DEVELOPMENT CONSENT AUTHORITY
DARWIN DIVISION

AGENDA ITEM: 1 **MEETING DATE**: 21/08/2026 **FILE:** PA2026/0031

APPLICATION PURPOSE:	**RECONSIDERATION** Dwelling-multiple (39 x 2 bedroom and 36 x 1 bedroom suites) in a nine storey building including two levels of basement car parking to be used as serviced apartments
SUBJECT SITE:	Lot 1462 (4) Lindsay Street, Darwin City, Town of Darwin
ZONE:	CB (Central Business)
SITE AREA:	944 m^2
APPLICANT	Sheridan Consulting – Director Joseph Sheridan
PERSONS ON WHOSE BEHALF THE APPLICATION IS MADE	Ashford Architects – Director Randal Ashford Dalmer Pty Ltd – Director Lita Astralita Connolly
LANDOWNER	
ANY PERSON WITH AN AGREEMENT TO ACQUIRE AN INTEREST IN THE LAND	None

SK1 - GROUND FLOOR & LEVEL 1 PLAN

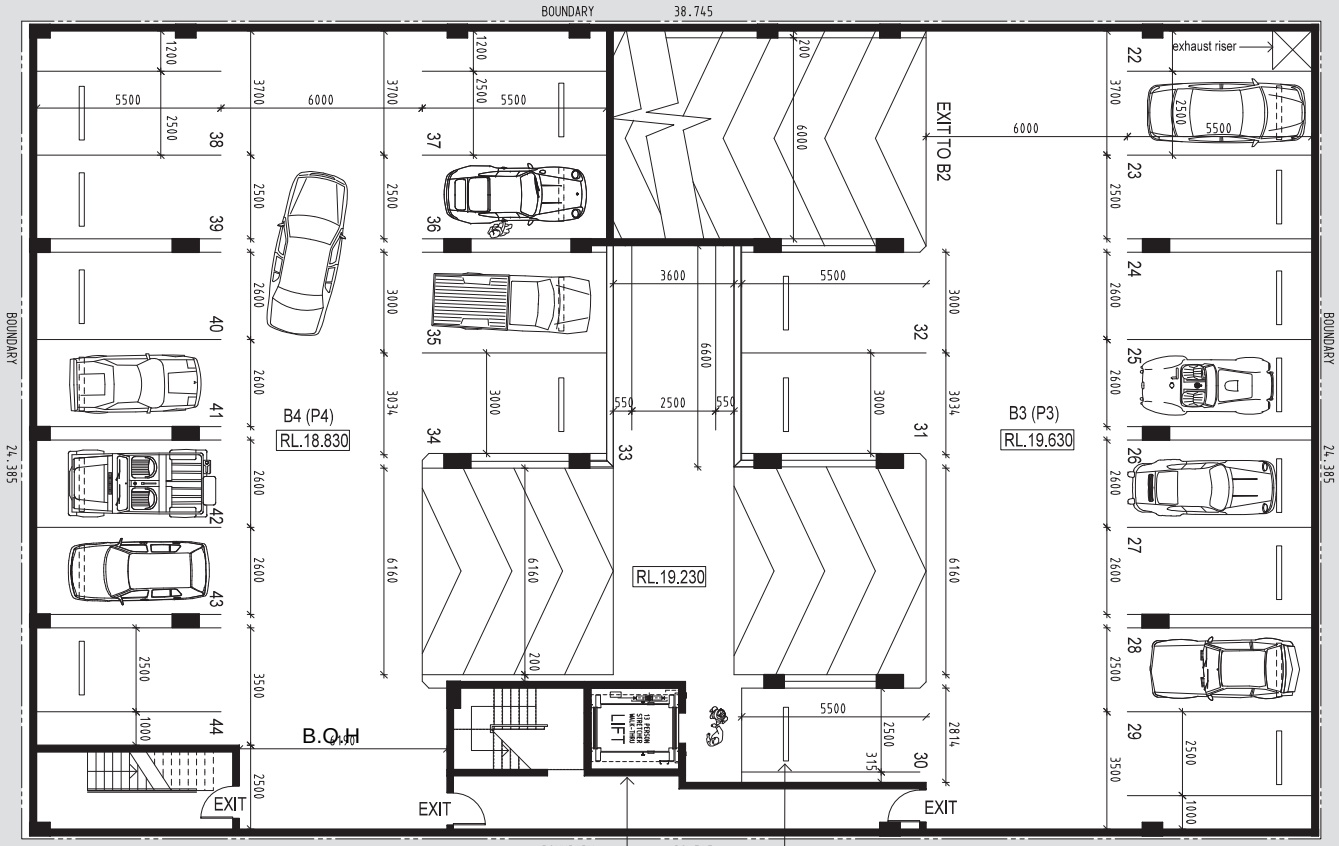
c) Provide a drop off/pick up bay within the Lindsay Street road reserve, to the requirements of the City of Darwin.

c) *Provide a drop off/pick up bay within the Lindsay Street road reserve, to the requirements of the City of Darwin.*

The amended plans show that in lieu of a dedicated drop off/pick up bay being provided within the Lindsay Street road reserve, that 2 short-term (15 minute limit) car parking spaces will be provided instead. The deferral response included a supporting letter from the City of Darwin. Of relevance, the following excerpt of that letter states:

- Increase in building height from 29 m to 29.3 m, as a result of the ground floor being lifted in response to substation servicing requirements from the Power and Water Corporation.
- Changes to nearby on-street parking to provide 2 short-term car parking spaces
- Provision of laundry stores on levels 2 through 9

> *After due consideration, in the interests of facilitating the progression of this development and supporting the economy of Darwin, City of Darwin is prepared to allow the use of two bays along Lindsay Street adjacent the development site, to be converted to 15 minute parking bays, to be installed at the developer's expense and available for public use.*
>
> *We are happy to receive concept drawings of the modified parking for review and approval in principle for the purposes of you providing amended drawings to the DCA.*

SK1 - GROUND FLOOR & LEVEL 1 PLAN

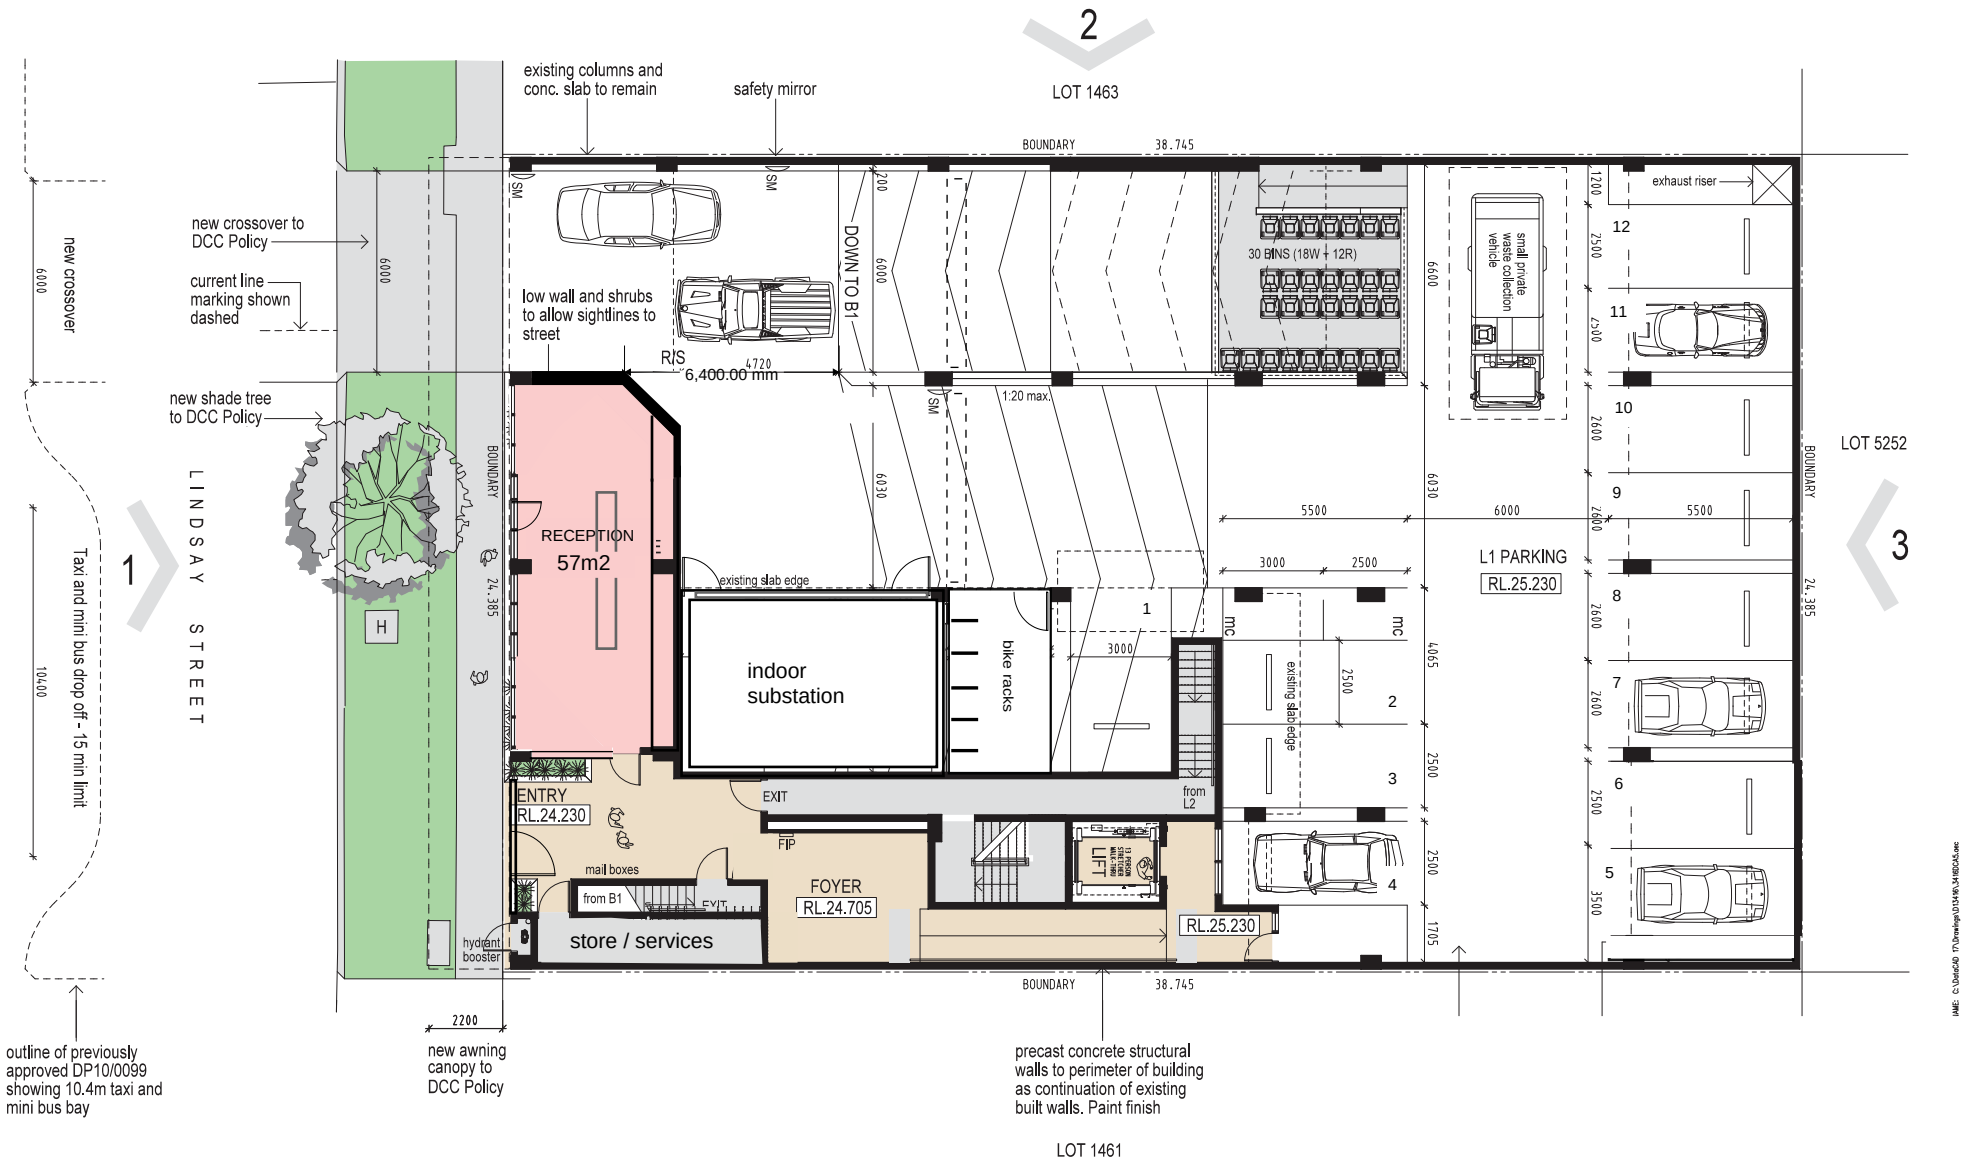
1. The proposed indoor substation location and dimensions as shown on the attached Drawing SK1 – Ground Floor & Level 1 Plan by Ashford Lamaya Architects (Randal Ashford) are accepted in principle by PWC for DAS assessment process.
